Fig. 1

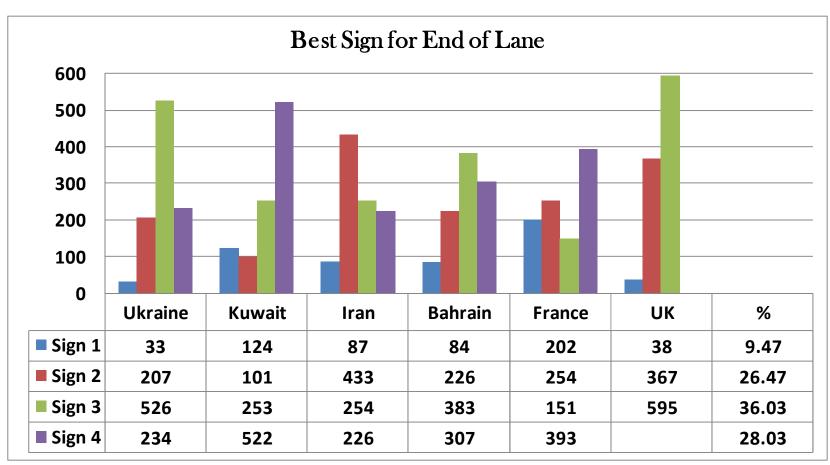
13= The convention says for warning of road narrower shall be given by the symbol A,1a or by a symbol showing the outline of the road more clearly, such as A,4b. We just can't see how two symbols could mean the same thing but one is more clearer that other. In our study we found both symbols are confusing to drivers, for example A,4b could mean and used in our roads in four different situations

The problem in this, is drivers need to change lane in a) and b) situation, but in c) and d) situation they only need to continue in their lane with caution. This is why we recommend to use symbol A,4b only in c) and d) situations and for a) and b) situation we should use a new symbol as Fig. 1. 1995 convention has added a symbol G,12a which is similar to the recommended new symbol.

What has been said about symbol A,4b is also true for symbol A,4a.

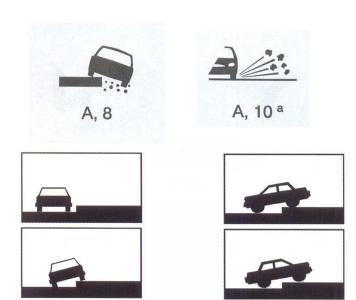
14= The symbol A,8 of a dangerous shoulders could be misunderstood, especially the symbol looks like one of the symbols which were added in the convention in 2009 as one of the parking methods, so symbol A,8 in a warning sign could be understood as not to park on the shoulder. We recommend to add a flying stones to symbol A,8 as in symbol A,10a to give it a feeling of a moving car instead of a stationary.

Fig. 4

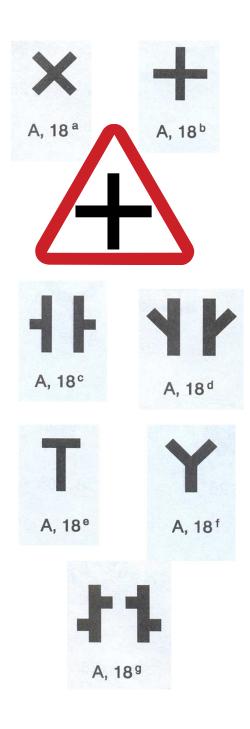
16= The convention has only one symbol to warn drivers from the possibility of children being in the road, which is symbol A,13. this symbol is used mostly near schools to warn drivers of children going or coming out from school. As there is one symbol for children, many time CP uses this symbol also at places where children are presence as near play gardens. The problem with this practice is most drivers associate this symbol to schools, so at afternoon or in holidays when children are most likely in play gardens or playing near their homes and a driver sees this sign he or she will not take precaution thinking this sign for schools and children are out of schools so there is no need to take precaution. We strongly recommend to add new signs to warn drivers the possibility of children presence at playing grounds and children playing near their homes as in fig.3 and fig.4, and use symbol A,13 only near schools.

## 22= Give way Sign:

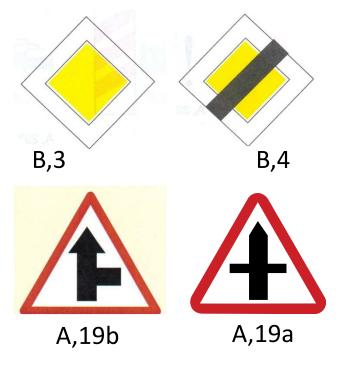
Studies has shown that the less abstract the sign is the more drivers understood and comprehended the meaning of signs. Give Way sign B.1 is an abstract sign that is why we recommend putting the wording "Give Way" in side the sign as many countries has done, this will improve the comprehension of the meaning of the sign , and in return we think it will increase drivers compliance to the order of the sign. Also as the convention has allowed CP to use yellow or white ground for the sign, we recommend that the convention explain why and where should color be used.
